George Hotel
Refurbishment (Planning & LBC)
Response – Cycle Storage

(File Ref: 2025_4891147_W - 15 - Response - Cycle Storage_29.08.25)

This mini-report seeks to record the matters pertaining to comments received from the elected member as outlined in the previous application (consented) Ref:2023_90112 and 2023/48/90024W.

The Lead planning officer Jillian Rann raised a concern that the previous application 2023/48/90024W, a condition was placed on the approval by request of the relevant elected member relating to the provision of cycle storage within the development and that this provision is likely to be required under the revised/ new application this report pertains to:

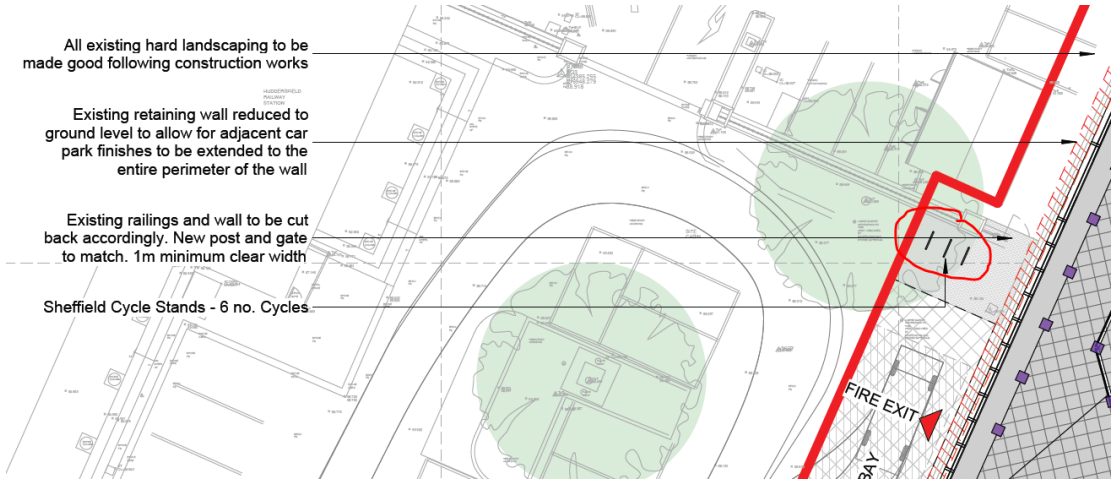
The applicant, agent and lead architect have been attending fortnightly meetings with the LPO and conservation officers and in meeting on 26July 2025 this matter was raised over concerns that the current application did not appear to allow for the provision of cycle storage.

On 02.07.25 AHR submitted additional information namely the site plan below which indicated the provision of 3nr Sheffield stand hoops to the side entrance/ railway station elevation (for 6nr cycles):

The applicant supplied this information with an explanation that the provision of cycle storage internally is extremely problematic from a fire compliance perspective due to recent concerns around electric cycles and lithium battery fires which could not reasonably be mitigated.
